ADDENDUM #6

PROJECT : CODESTACK ACADEMY

REF. # : ARCH PROJ. No. 2023-04

DATE : 21 March 2025

9 ROOF TO PARAPET @ EAST ELEVATION

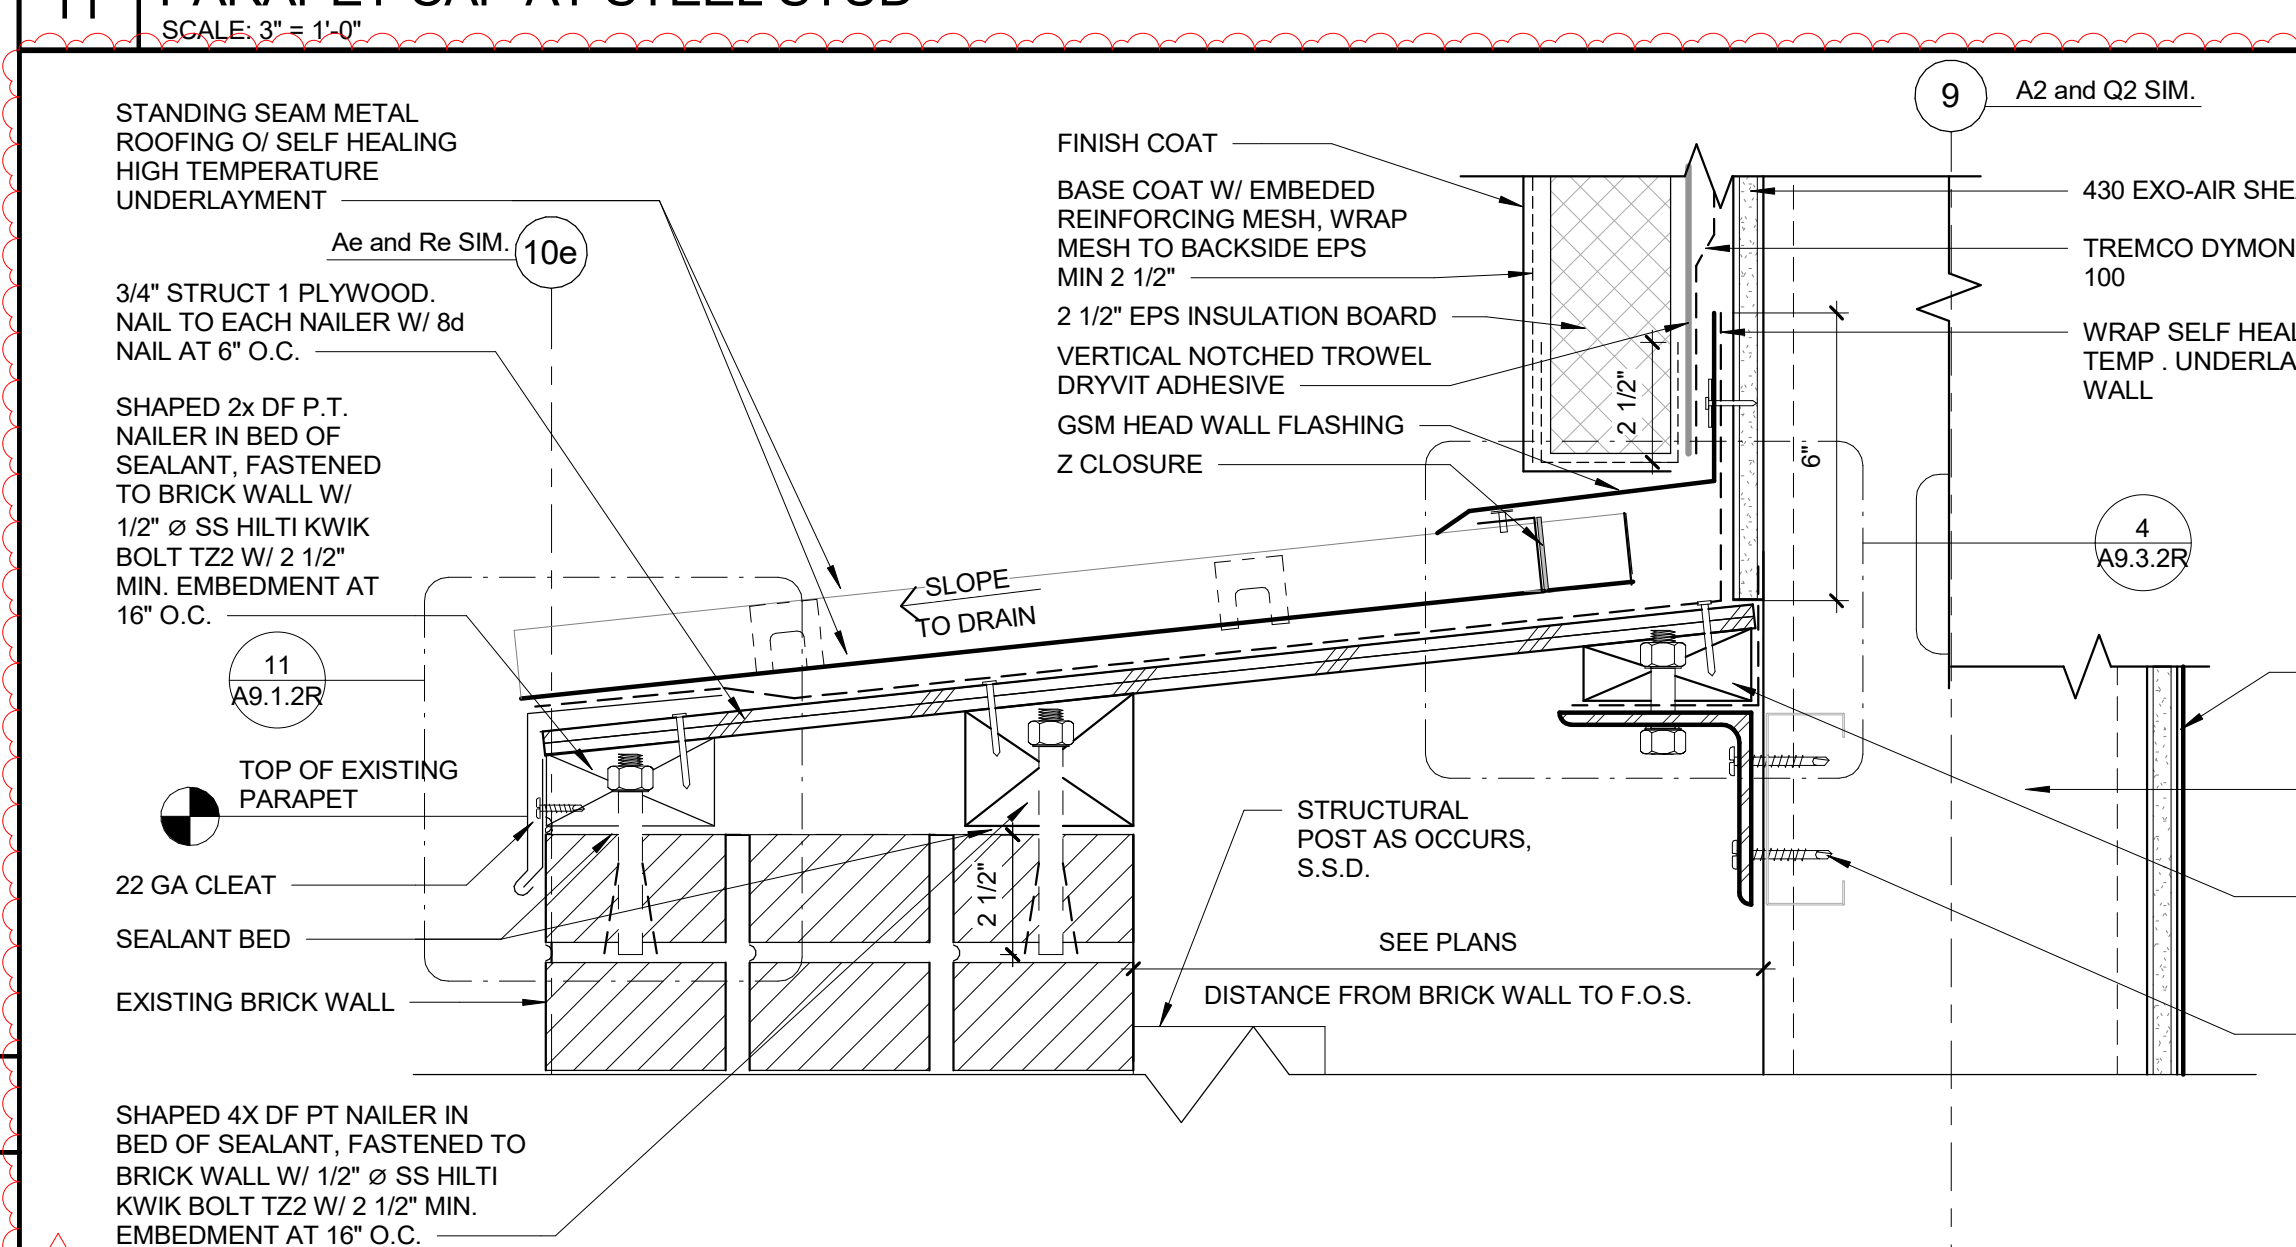
ITEM 04 QUESTION (03.11.25): 9/A9.3.2. shows a 3x3 support angle attached to the existing brick and the deck running to the brick. Structural drawings show that the roof deck stops short of the brick wall and the tube steel brick wall supports run from the 3rd floor slab past the roof deck and up to the parapet. Please confirm if 9/A9.3.2 will be revised to match structural?

In the same detail (9/A9.3.2), the detail shows what appears to be sloping plywood from the new framed wall to a shaped 2x at the top of the brick wall. Please provide details for plywood. Is this material required to be treated and provide details for plywood including thickness?

RESPONSE: Detail 9/A9.3.2 has been revised to match structural framing. 3x3 angle has been removed, and parapet cap attachment has been revised. See revised sheet A9.3.2R, detail 9 (attached).

EE TRASH ENCLOSURE-FRAMING PLAN
1/4" = 1'-0"

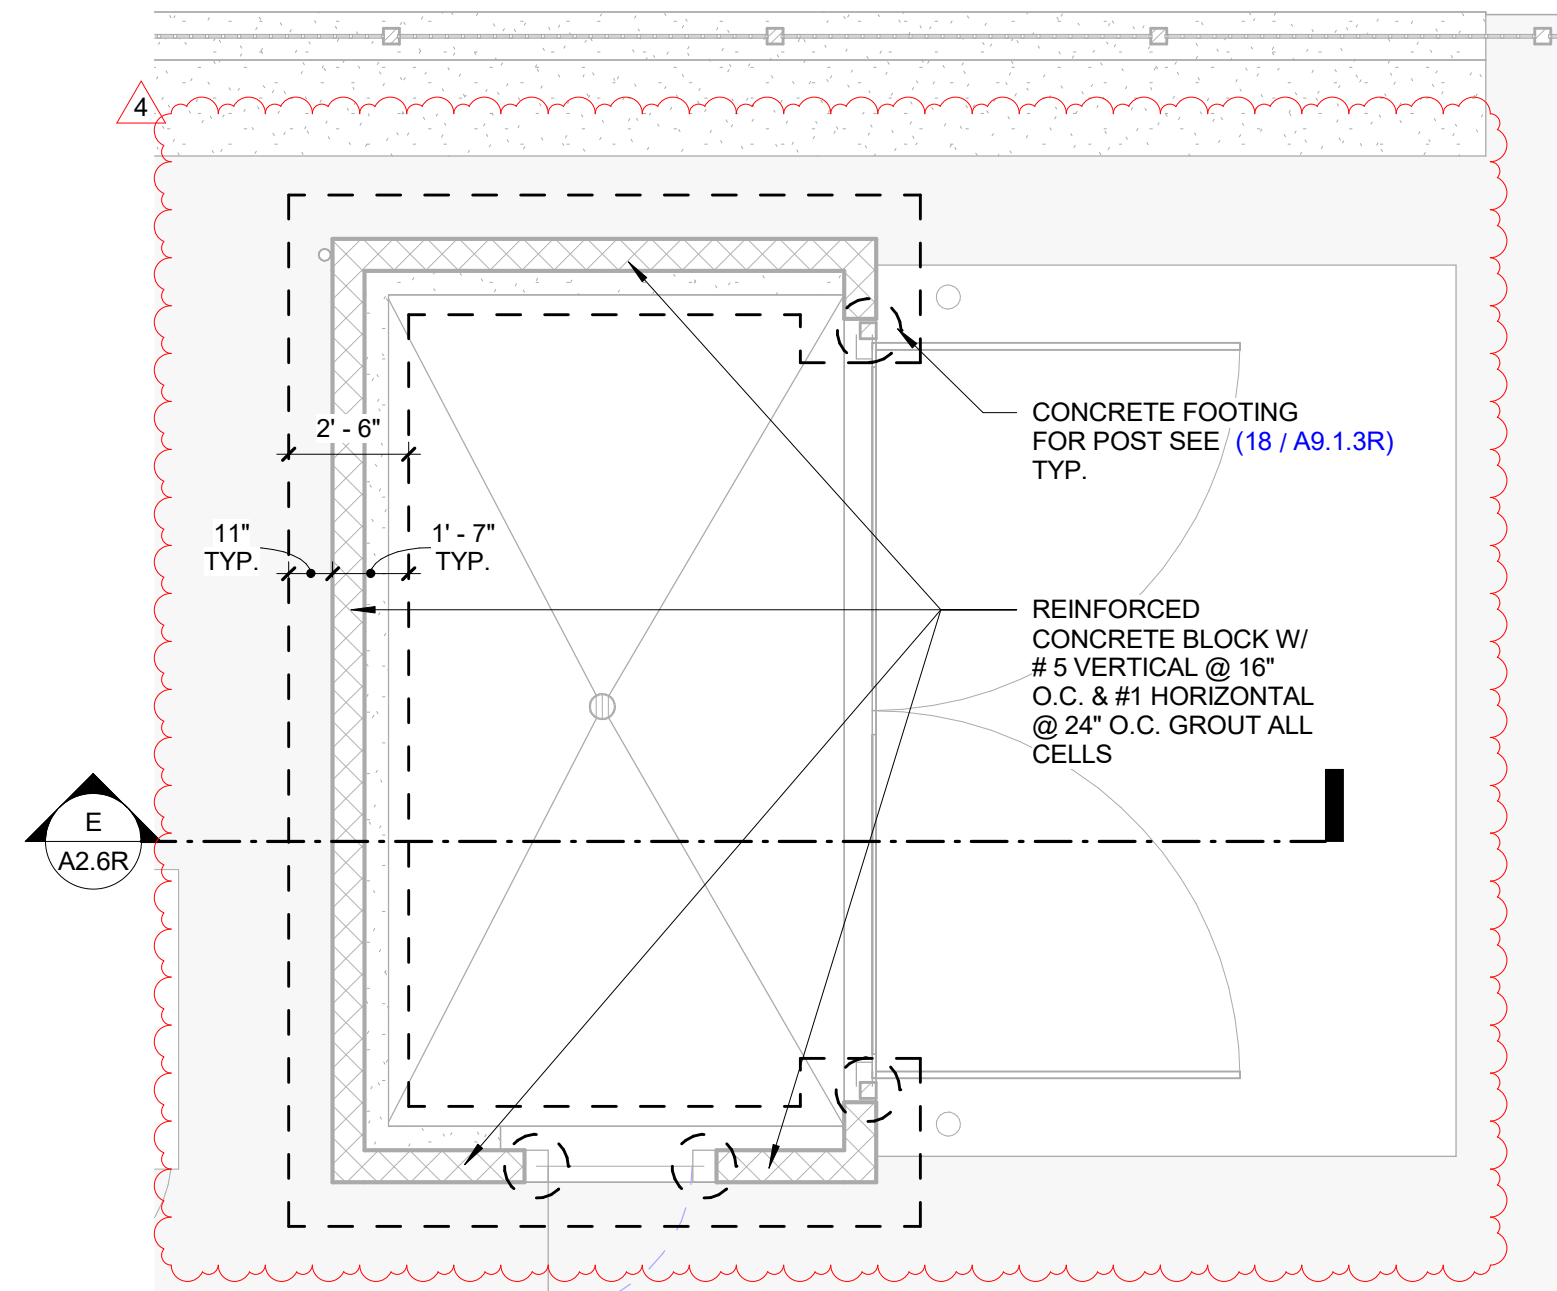
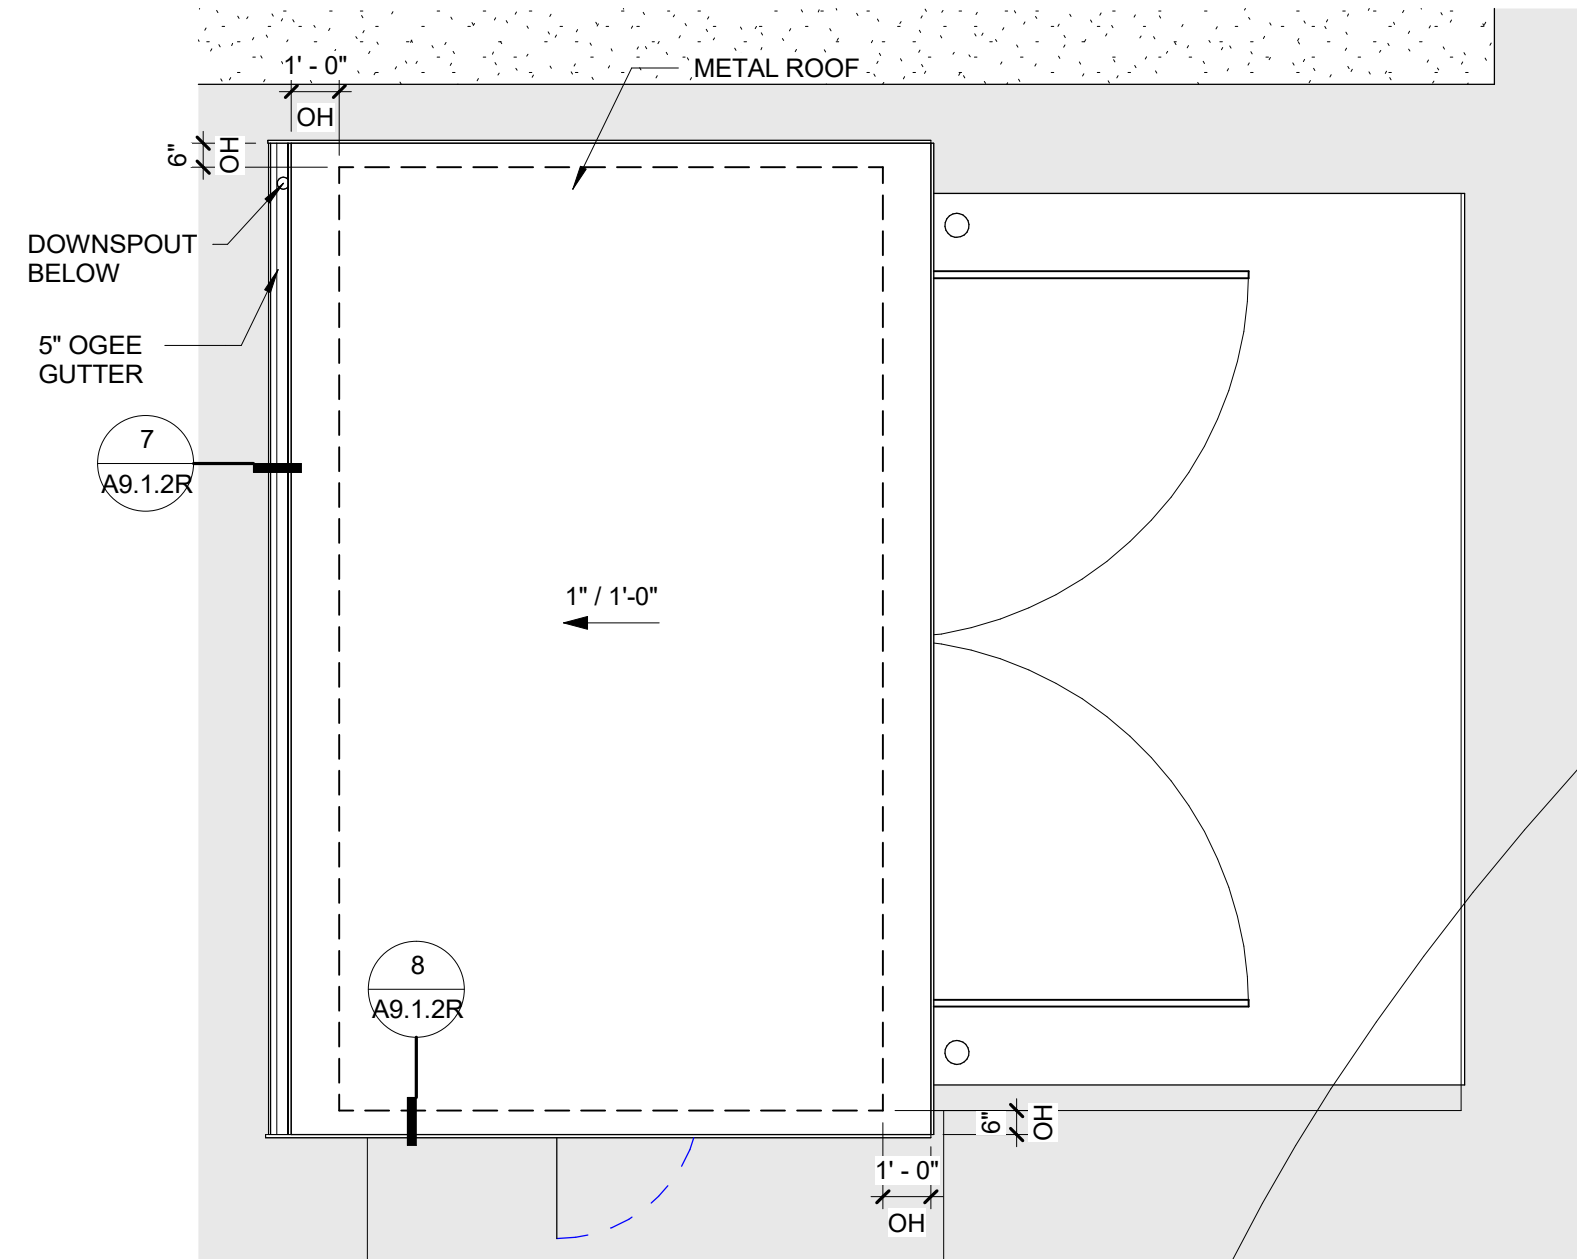
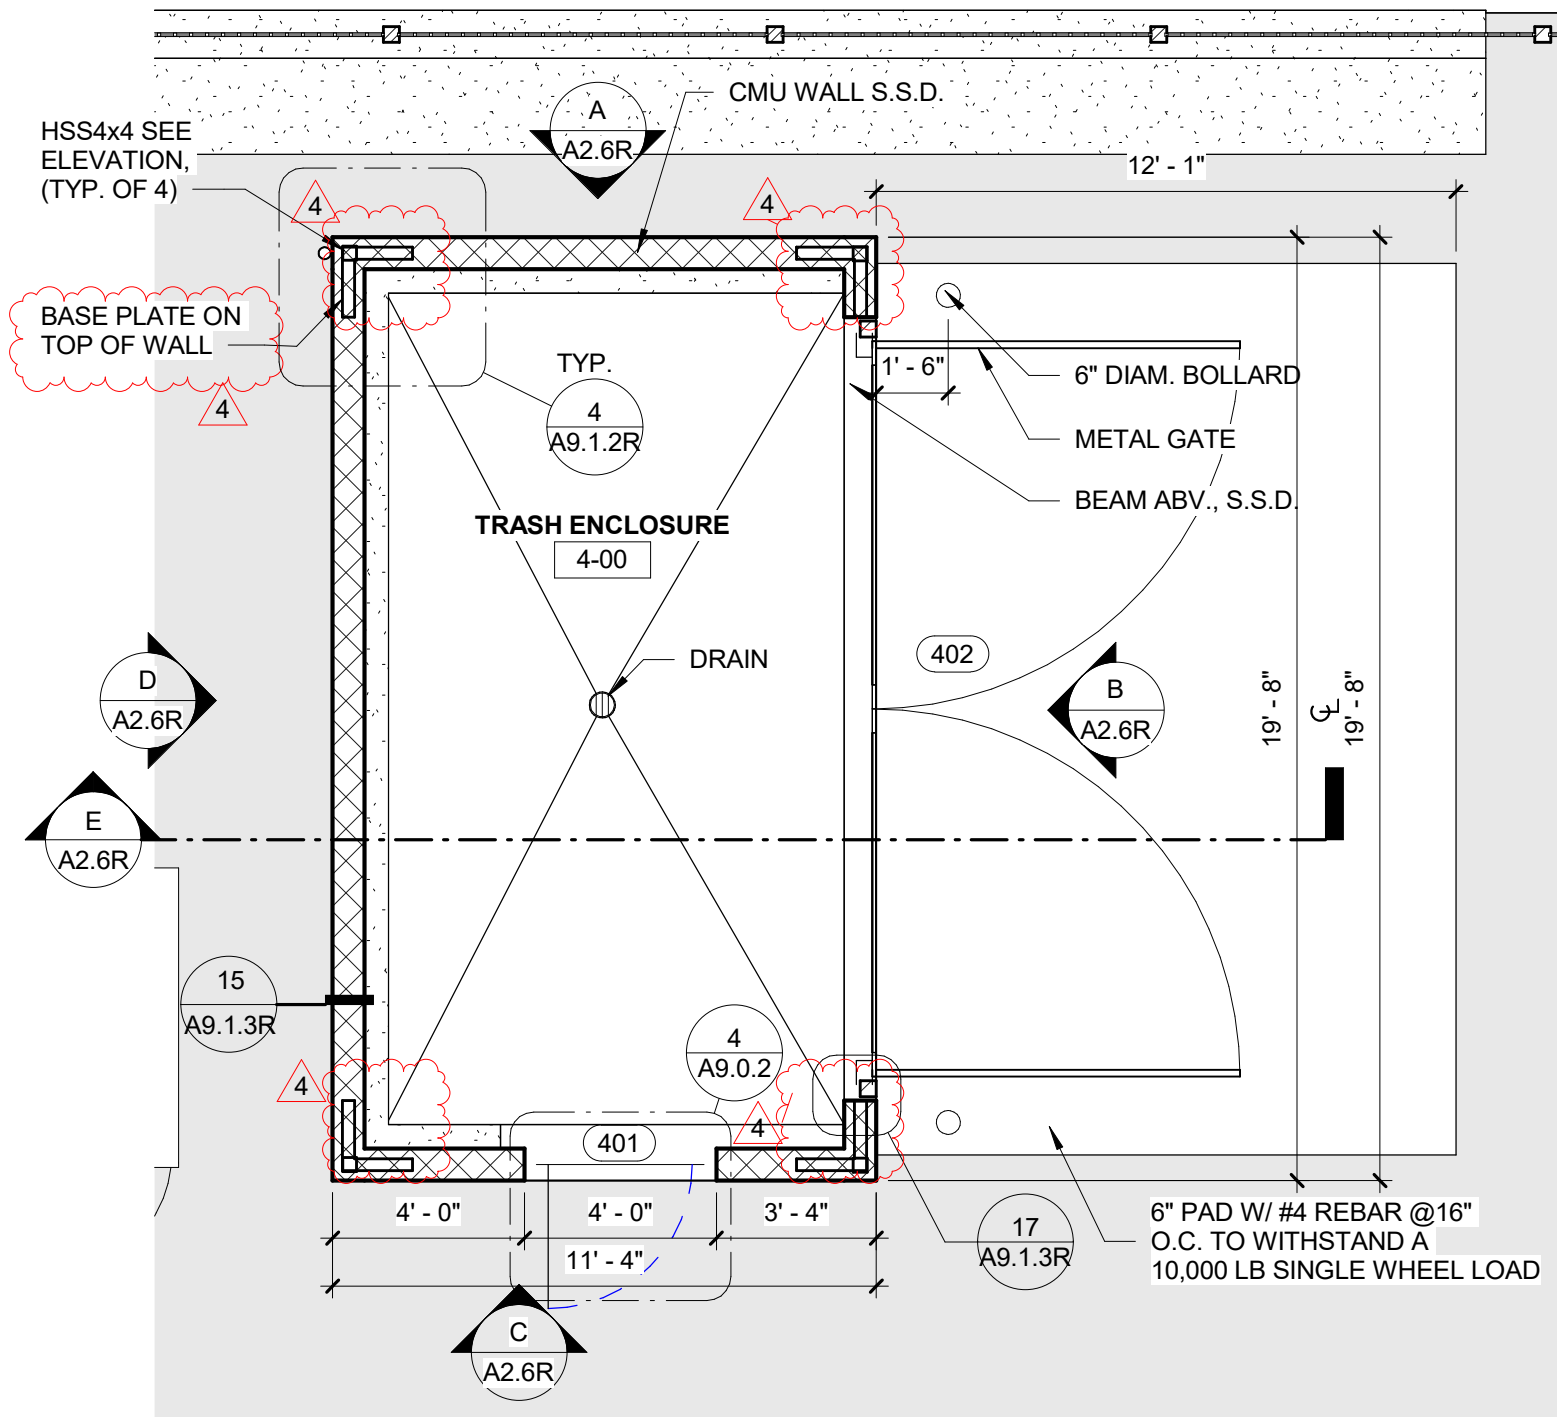
Are there any structural details for trash enclosure? Details D & E on A2.6 and 16/A9.1.3 refer you to structural drawings for roof framing at trash enclosure. Please confirm what structural details are to be followed for roof framing and sheeting at trash enclosure.

RESPONSE: New Architectural details have been provided for the trash enclosure Roof framing and foundation plan. See revised sheet A9.1.2R Details 4, 7, 8, & 12. (attached). See also, revised sheet A2.6R (attached) for revised detail callouts.
